SUNDRY NOTICES AND REPORTS ON WELLS

Puerto Chiquito Mancos

26

Attachment to Notice of  
Intention to Abandon

# # 26 Puerto Chiquito

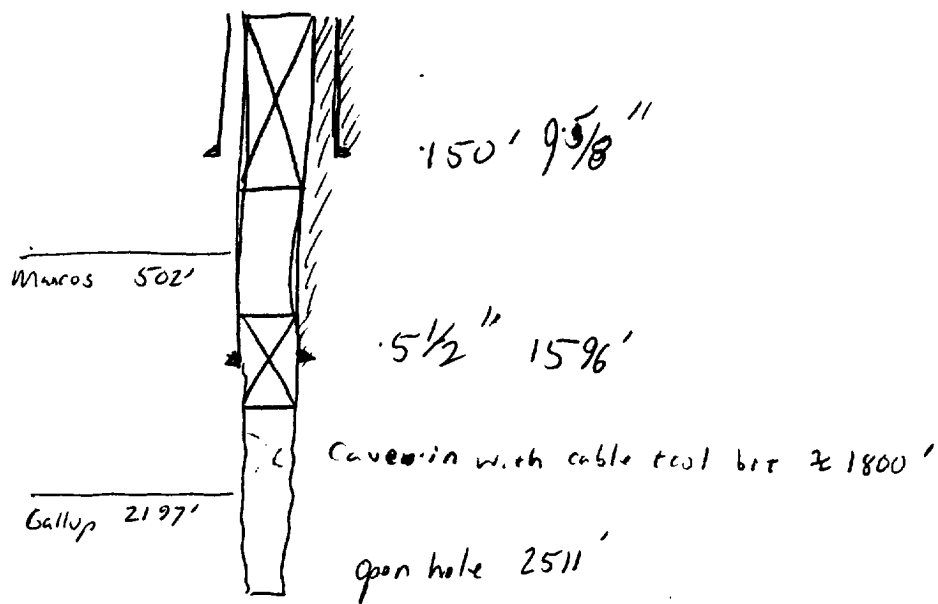
Operator proposes to plug and abandon this well by spotting 2 25-sack plugs as follows:

Plug #1 1650' - 1550'  
Plug #2 200' - 0'

Plug # 1 1650 - 1550' (25 SX)

Plug # 2 200 - 0 (25 SX)

1. Plugging operations authorized are subject to the attached "General Requirements for Permanent Abandonment of Wells on Federal Leases."
2. Mark Kelly with the Farmington Office is to be notified at least 24 hours before the plugging operations commence (505) 327-5344.
3. Blowout prevention equipment is required.
4. The following modifications to your plugging program are to be made (when applicable):
